SUBJECT: NuScale Power, LLC Supplemental Response to NRC Request for Additional Information No. 83 (eRAI No. 8899) on the NuScale Design Certification Application

NuScale Supplemental Response to NRC Request for Additional Information eRAI No. 8899

eRAI No.: 8899

NRC Question No.: 19.01-2

Figure 19.1-16: Representative Seismic-Initiating Event Tree

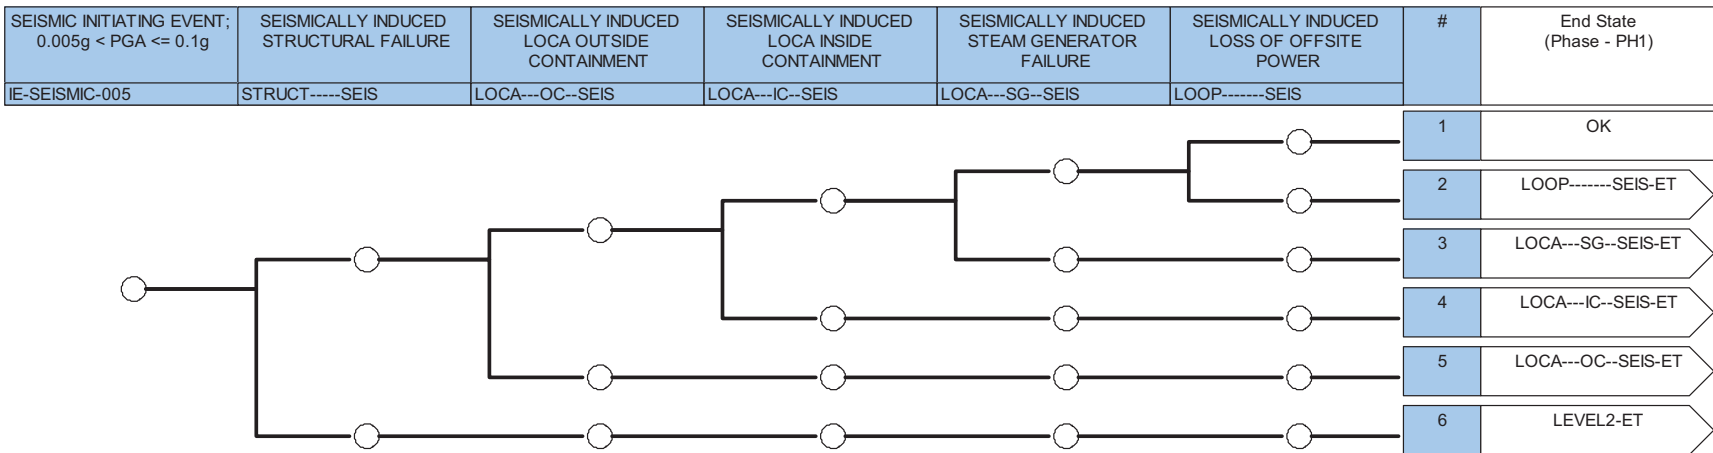
In FSAR Tier 2, Section 19.1.5, the staff identified the use of the terms “PRA-critical” and “Non-critical.” The staff requests that the applicant provide a definition of the terms “PRA-critical” and “non-critical” that are consistent with their usage as listed below and applicability to the PRA-based SMA.

Additionally in Section 19.1.5.1.1.3, the 2nd paragraph describes the methodologies used to determine the seismic capacity and demand for the SMA. The staff requests that the applicant clarify if the 1st sentence in that paragraph is referring to PRA-critical structures and components. The applicant should also clarify if non-critical components are modeled in the SMA and whether there are any non-critical structures.

~~The seismic hazard for the NuScale design has been partitioned into 14 seismic initiating event trees defining the SMA. The underlying logic for each tree is identical. However, each tree represents a different ground motion acceleration.~~ The seismic hazard for the NuScale design SMA is partitioned into fourteen seismic event trees. The underlying logic for each event tree is identical; however, each event tree represents a different ground motion acceleration (each seismic event tree represents a portion of the ground motion range from 0.005g to 4.0g). In the SMA, the use of multiple ground motions provides insights into the relative contributions of both seismic and random failures at different ground motions. Figure 19.1-16 is a representative seismic event tree, corresponding to a range of peak ground accelerations from

Each event tree is assigned a ground motion acceleration increasing monotonically from 0.005g to 4.0g. The seismic initiator event tree provided as Figure 19.1-16 corresponds to a range of peak ground accelerations from 0.005g to 0.1g. The thirteen remaining event trees represent ground motion ranges spaced accordingly up to 4.0g (0.1g to 0.2g, 0.2g to 0.4g, ..., 2.0 to 2.5g, ..., 3.0g to 4.0g). Component failure probabilities are then evaluated at the mid-point of each range (0.0525g for a range of 0.005g to 0.1g, for instance). This methodology supports site-specific estimates of seismic hazard occurrence frequency. Each ground motion initiator is a SAPHIRE initiating event with a frequency set to unity. This allows for an evaluation of conditional core damage or large release probability at each ground motion.

Seismically-induced event trees are initiated by the failure of a single component or structural event. Sequences containing these failure events transfer from Figure 19.1-16 to other seismic event trees that represent plant response to breaks outside containment (Figure 19.1-17), LOCAs inside containment (Figure 19.1-18), SGTfEs (Figure 19.1-19), and losses of offsite power (Figure 19.1-20). Figure 19.1-17 and Figure 19.1-19 include a transfer to a loss of DC power event tree (Figure 19.1-20a) to reflect battery depletion at 24 hours. These trees are modified from existing internal events PRA event trees to remove credit for the availability of AC power or for offsite power recovery.
